**PREVOST**

**WARRANTY  
BULLETIN**

Wb07-03

<b>DATE:</b> MAY 2007	<b>SECTION:</b> 23 - Accessories
<b>EXPIRATION:</b> MAY 2009	
<b>SUBJECT:</b> INSTALLING DECAL WARNING AGAINST PERFORMING ANY WELDING WORK

FIGURE 1

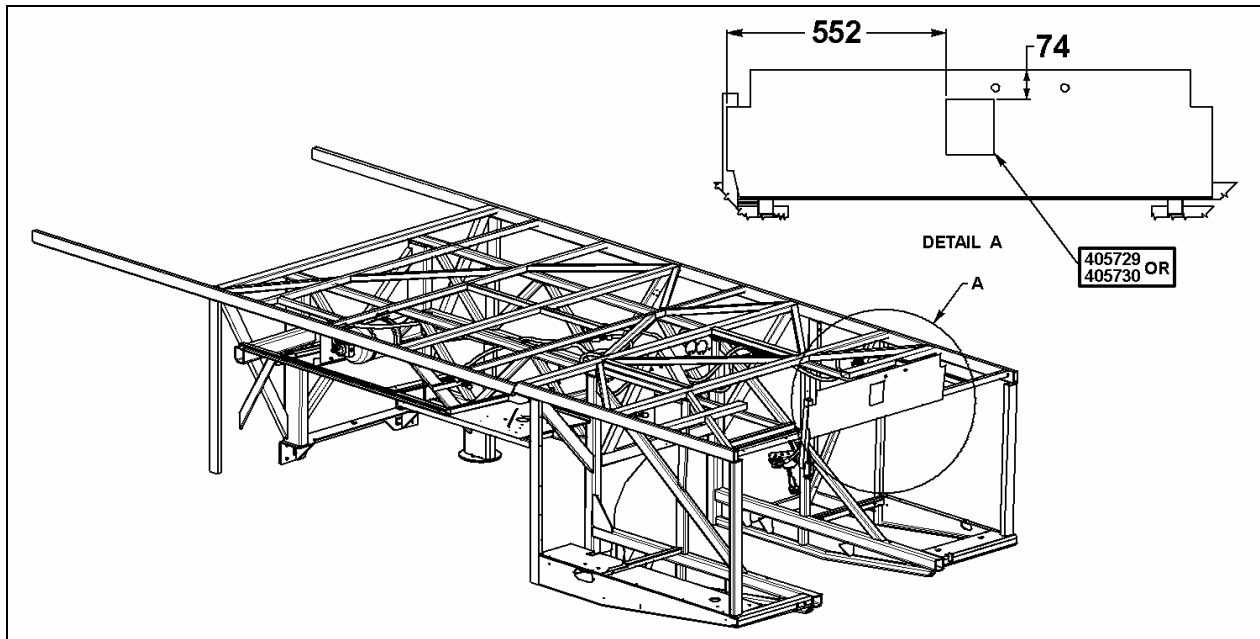
On the above-mentioned vehicles, there is a possibility that the decal warning against performing any welding work when the vehicle is equipped with an Automatic Fire Detection and Suppression System (AFSS), was not installed in the engine compartment.

The system might activate by mistake if arc or gas welding is performed.

1. Open engine compartment door then check if decal was installed, if not install as per figure 1.

Choose the proper decal according to the requirements.
